SEWAGE DISPOSAL SYSTEM

MARYLAND STATE DEPARTMENT OF HEALTH

HOWARD COUNTY

SUBDIVISION _____ ROAD 7036 Mink Hollow Rd LOT

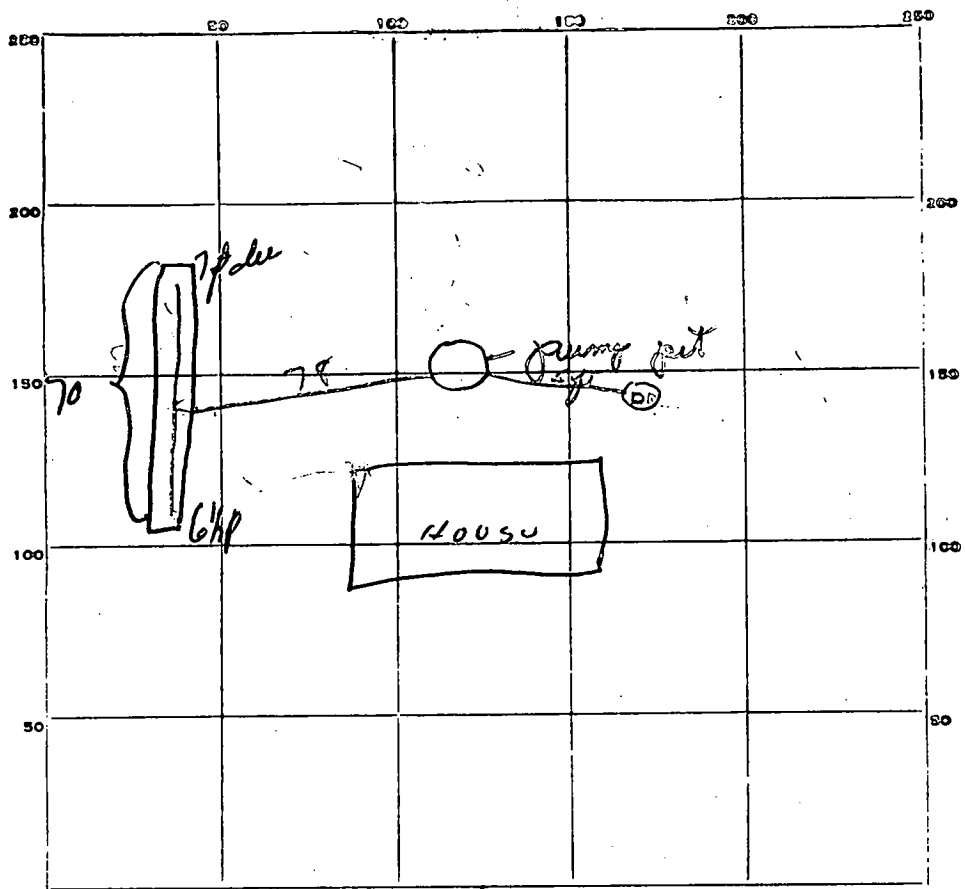
12-9-71 - trench 70 ft long 2 ft wide - 66 7/8 deep - 5 ft of gravel under pipe. Pump to be installed with water proofed pump pit
DWM

REMARKS *AM 12-9-71 - OK to put gravel in trench*
PM 12-9-71 - OK to cover trench - call for final insip
when pump pit etc is ready DWm
